**GARVEY COMMONS/
 SHERBURNE HALL
 ADDITIONS & REMODELING**
 ST. CLOUD STATE UNIVERSITY
 ST. CLOUD MINNESOTA

A-9

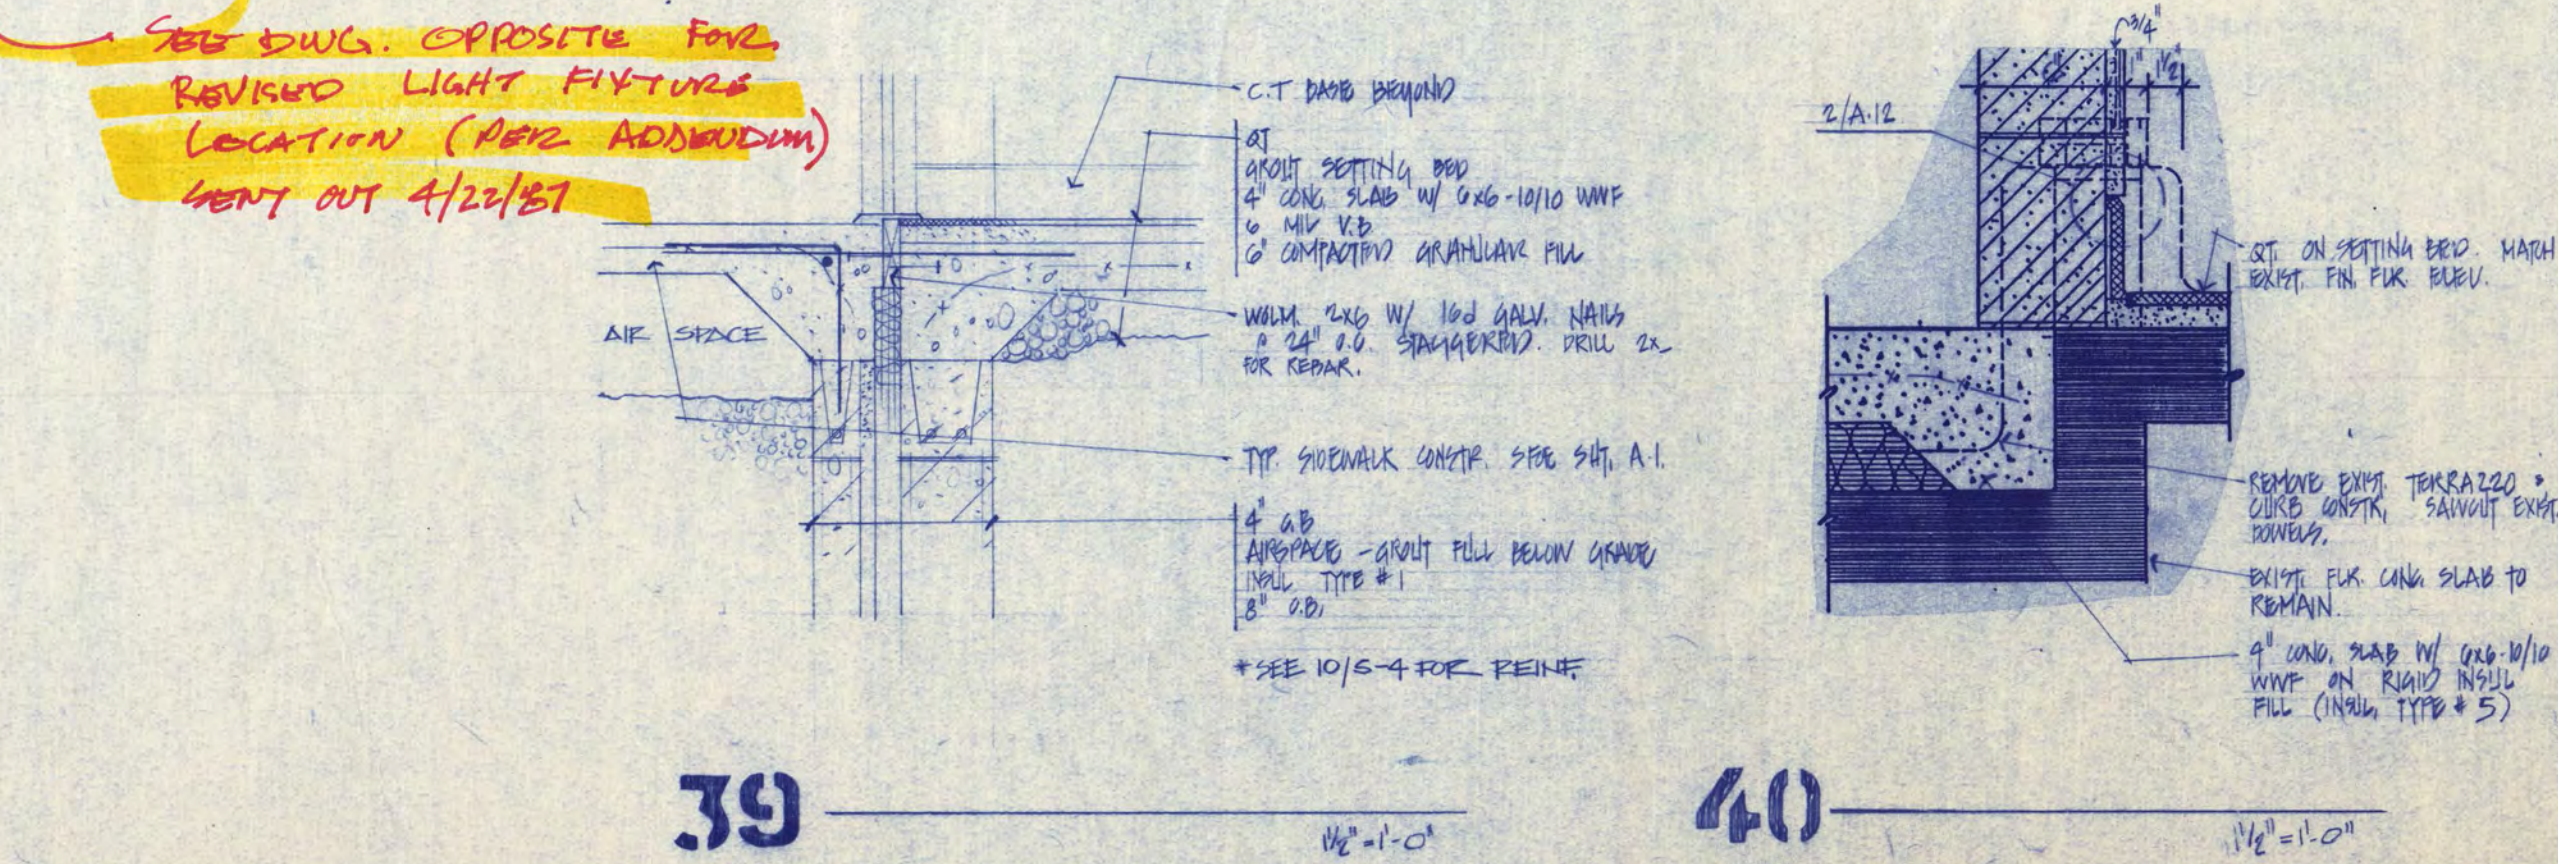
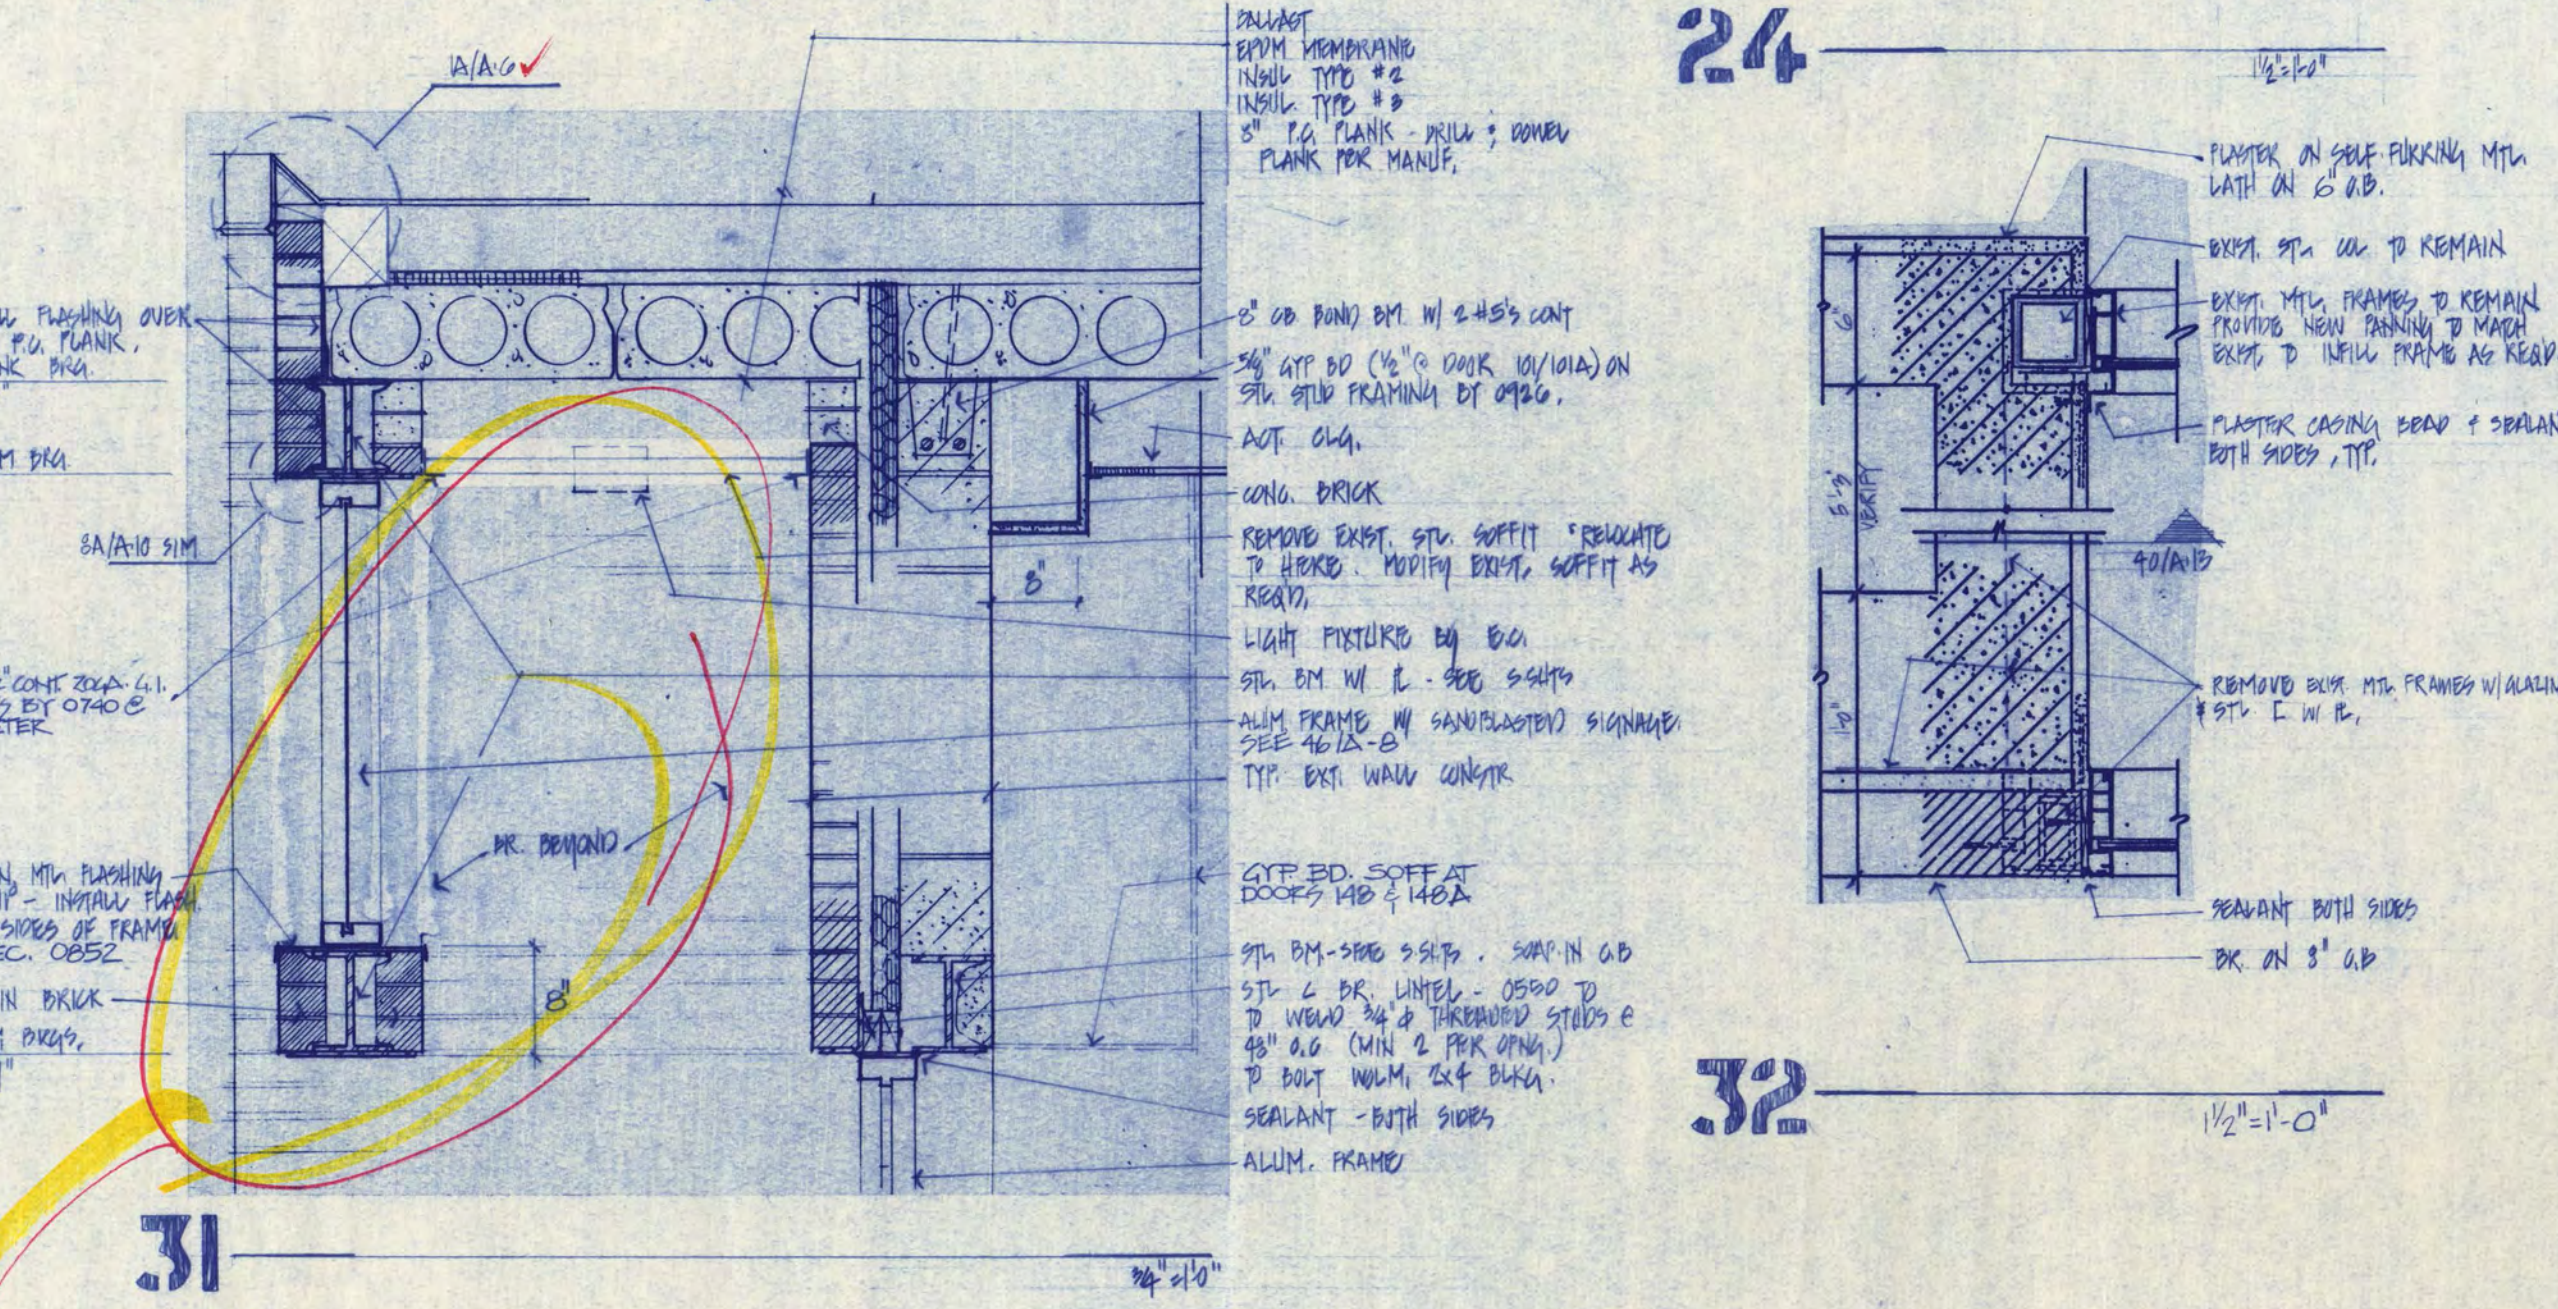
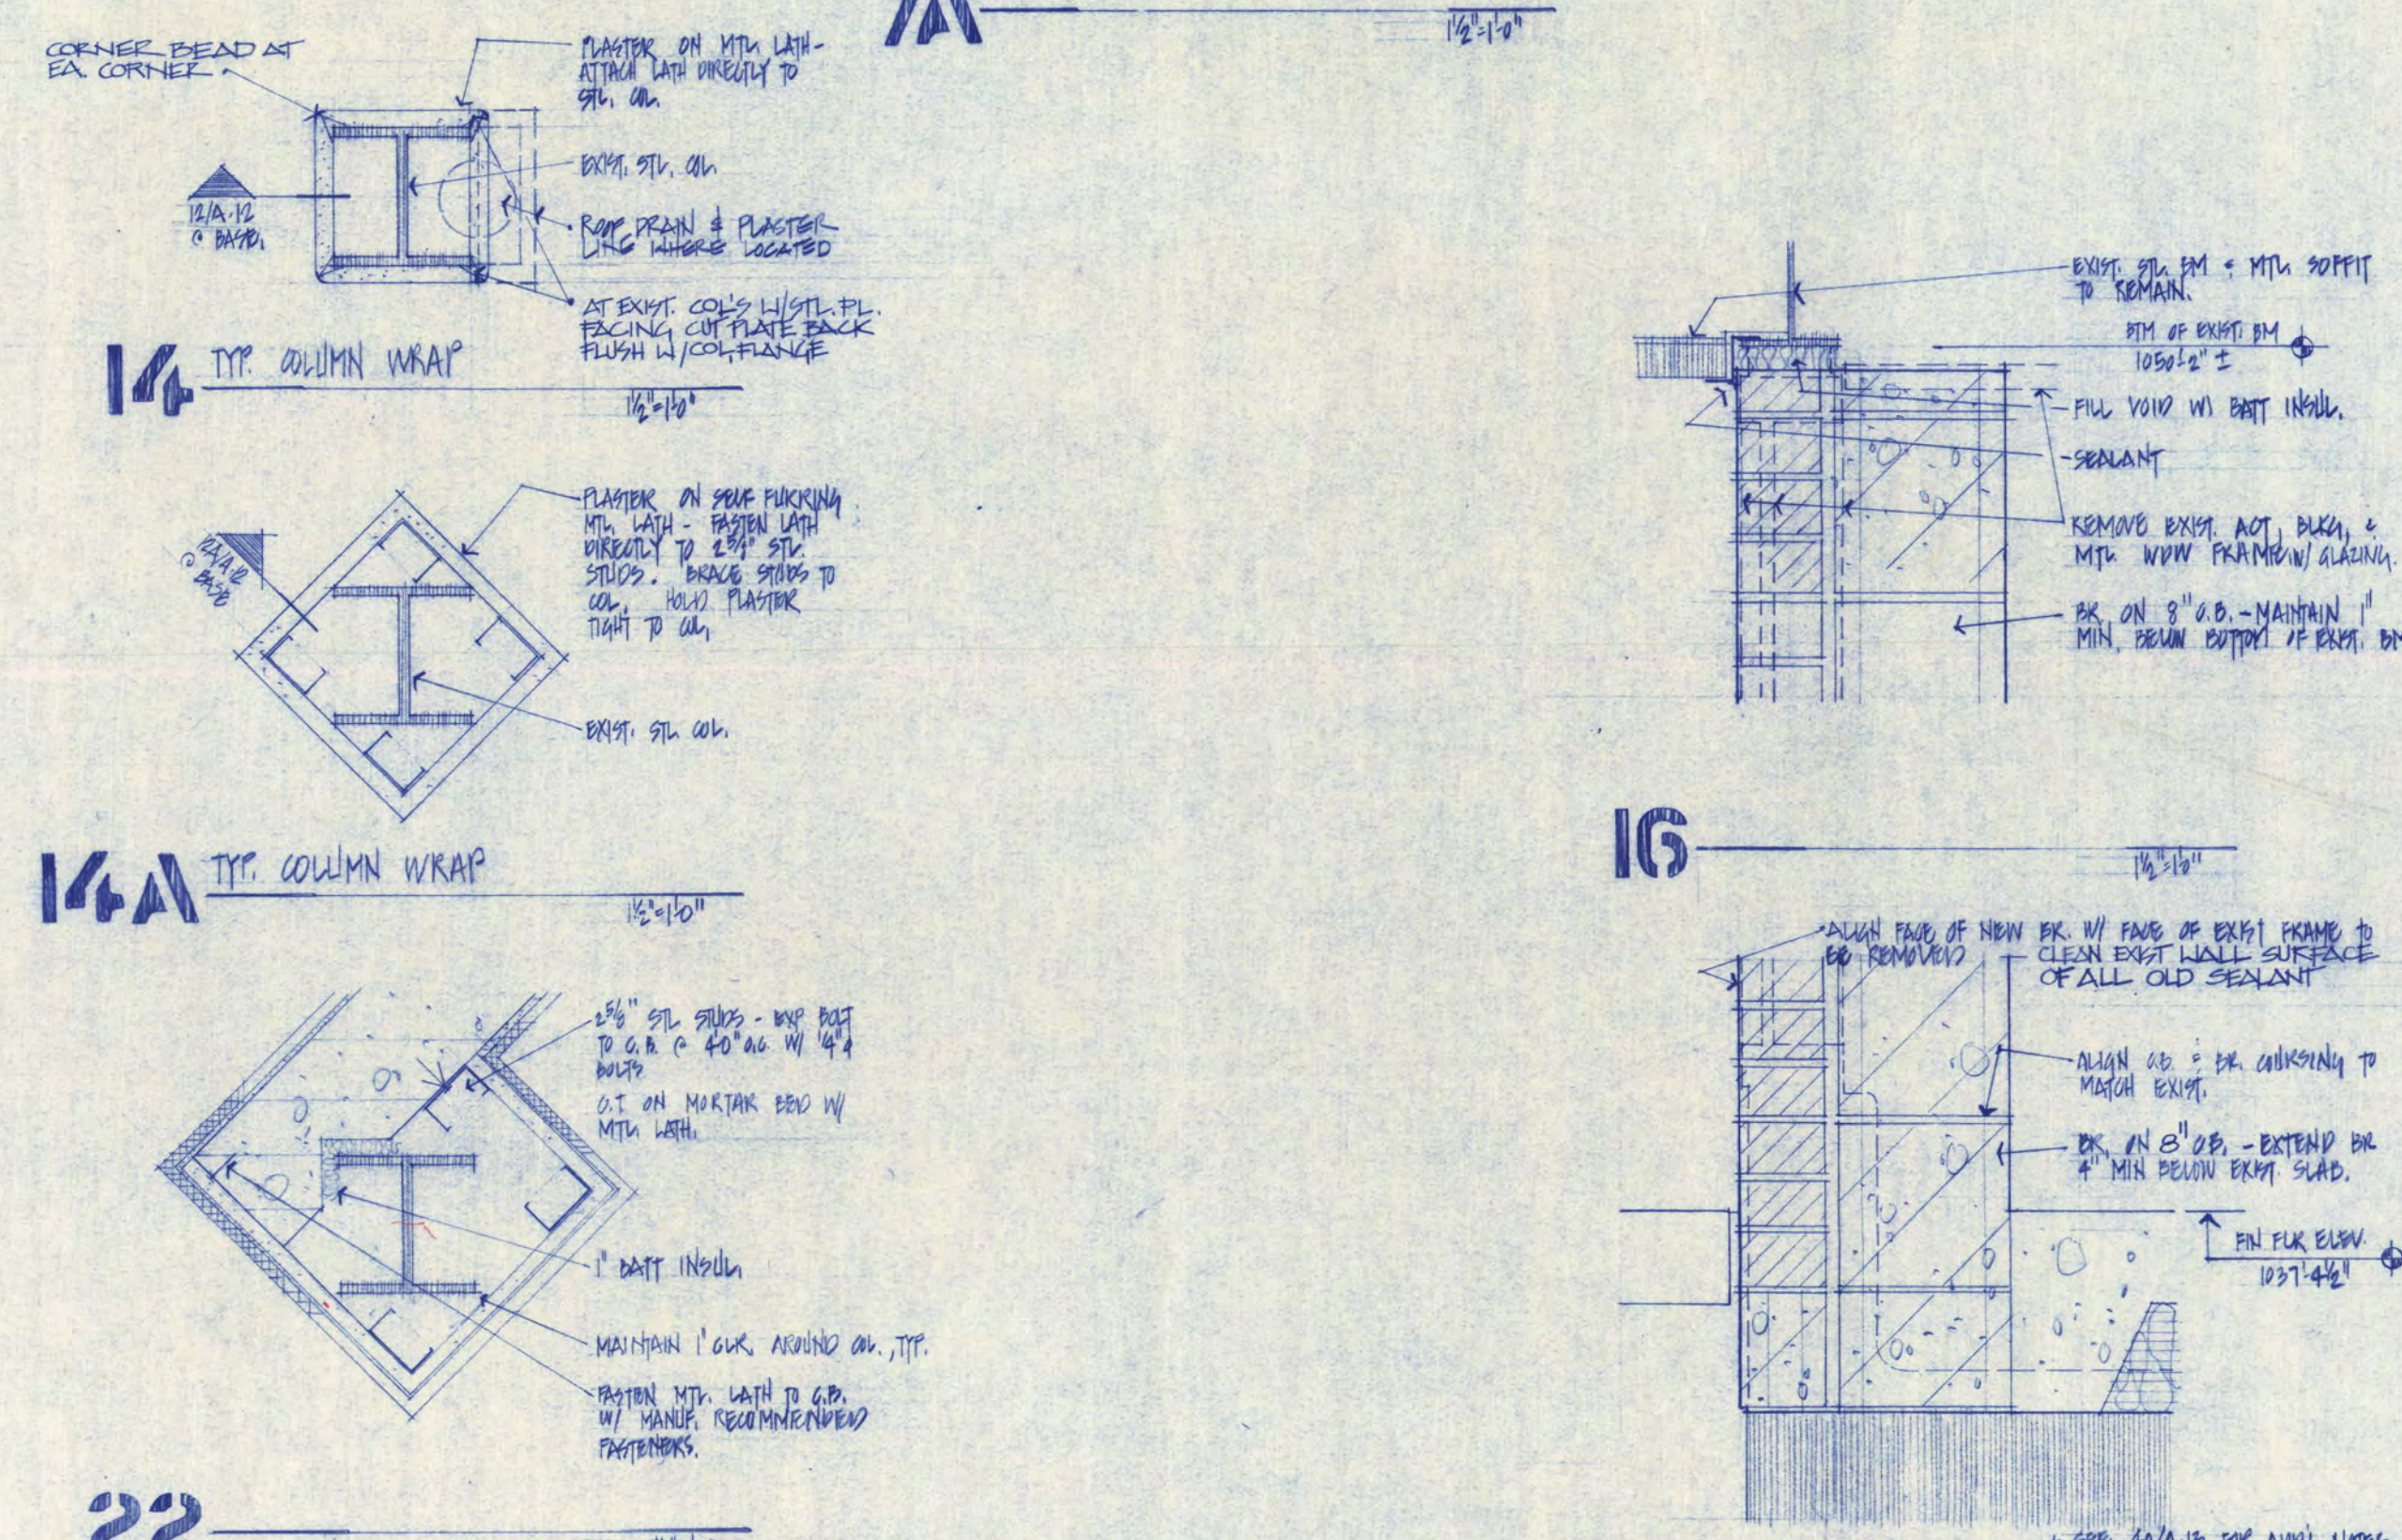
80. Detail 7A: At existing column 58, increase the size of enclosed area around the column to conceal refrigerant piping by the FSEC. The General Contractor shall core drill the existing floor slab at this location for refrigerant piping by the FSEC. Verify location(s) of holes with the Architect.

81. Detail 11: The existing exterior wall at the first floor level which is noted for removal is a cast-in-place concrete and face brick wall similar to Sheet SD-1 issued with this Addendum. The dashed double line and footing at the basement level represent existing columns and footings beyond which are to remain.
